PROJECT NAME: **Pre-K and Art Room Improvements**

OWNER / CLIENT: **West Michigan Academy of Arts and Academics**

ISSUE DESCRIPTION: **Addendum A**

In general terms, the work of this package includes **Addendum items** for the **WMAAA Pre-K and Art Room Improvements** project located in **Spring Lake, MI**.

9 HANDRAIL DETAIL
SCALE: 3/4" = 1'-0"

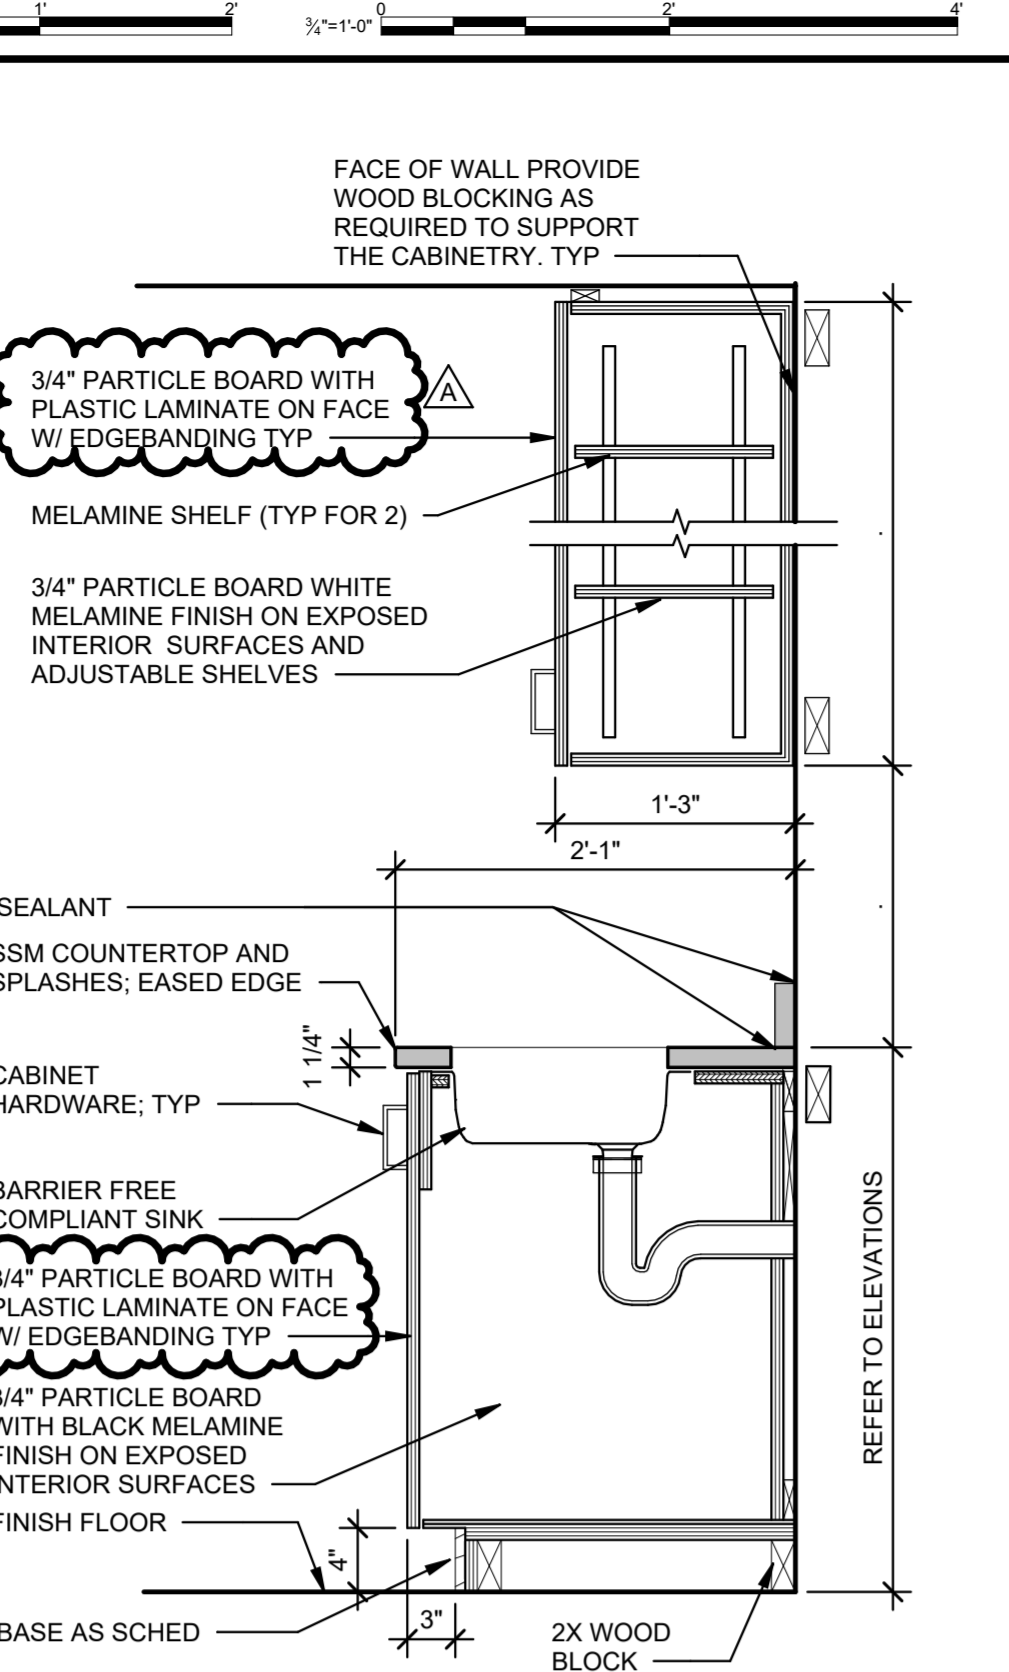
- Sheet #AE1-01-01 (reissued)
 - Updated General Notes and millwork details to indicate PVC edgebanding required for millwork door and drawer fronts.
 - Refer to demolition key notes and demolition plan for clarification of existing residential type exhaust fan in Toilet #102 upper gypsum board ceiling to be replaced; roof vent cap may remain for reuse or replace if not in good working condition.
 - Refer to Floor Plan Pre-K and revised Key Note 11: Revised supported stoop to provide handrails, trench drain, stair and short connecting sidewalk to address grade elevation above finished floor, and restoration of grading and wood chips.
 - Added Detail 9 – Handrail Detail as provided.
